**ADDENDUM NO. 2 TO PROJECT NO. 44720  
CONSTRUCTION WORK, HVAC WORK, ELECTRICAL WORK  
REPLACE COOLERS AND FREEZERS  
BUILDING NOS. 15 AND 89  
ATTICA CORRECTIONAL FACILITY  
639 EXCHANGE STREET  
ATTICA, NY**

November 7, 2014

**SK-A001**  
 Reference Sheet: 1/A-101  
 Date: 06 NOV. 2014  
 Project Number: 13016.00

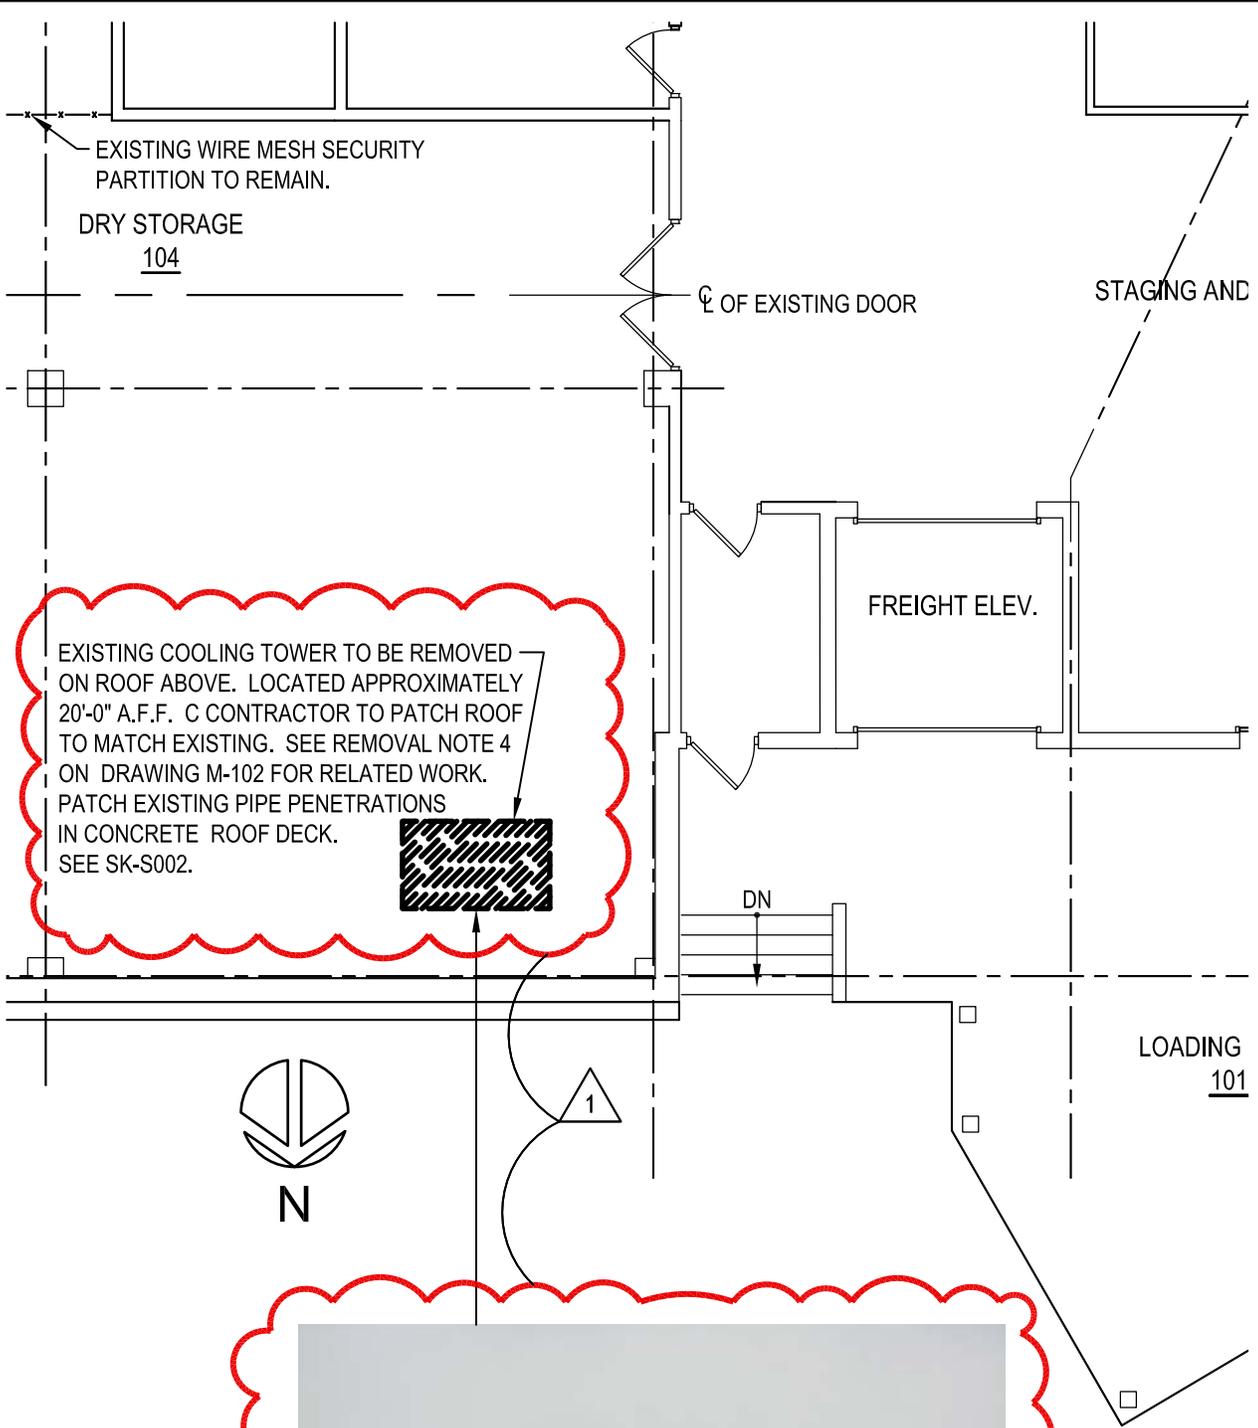
9. Refer to Drawing M-102 FIRST FLOOR PLAN REMOVALS HVAC, Refer to attached Sketchs SK-A001 and SK-S002, for repairing of the existing EPDM roof after the removal of the existing cooling tower.

EXISTING COOLING TOWER TO BE REMOVED ON ROOF ABOVE. LOCATED APPROXIMATELY 20'-0" A.F.F. C CONTRACTOR TO PATCH ROOF TO MATCH EXISTING. SEE REMOVAL NOTE 4 ON DRAWING M-102 FOR RELATED WORK. PATCH EXISTING PIPE PENETRATIONS IN CONCRETE ROOF DECK. SEE SK-S002.

**1** **EXIST. COOLING TOWER  
PIPING PENETRATION INFILL**  
N.T.S.

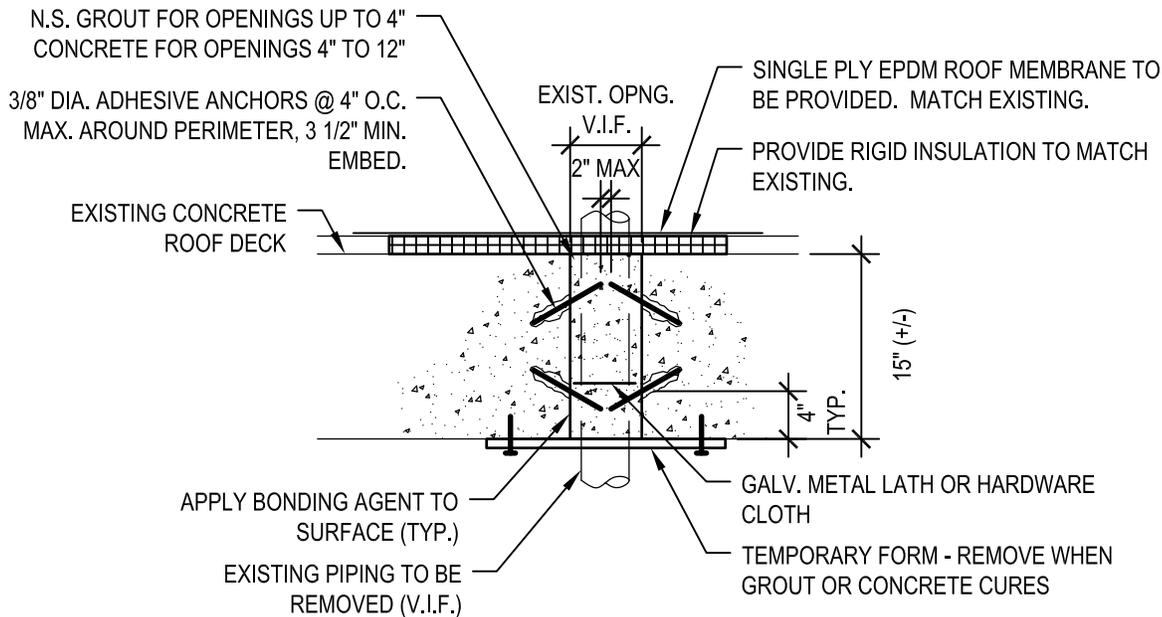
NOTIFY DIRECTOR'S REPRESENTATIVE  
IF OPENINGS LARGER THAN 12" ARE  
DISCOVERED
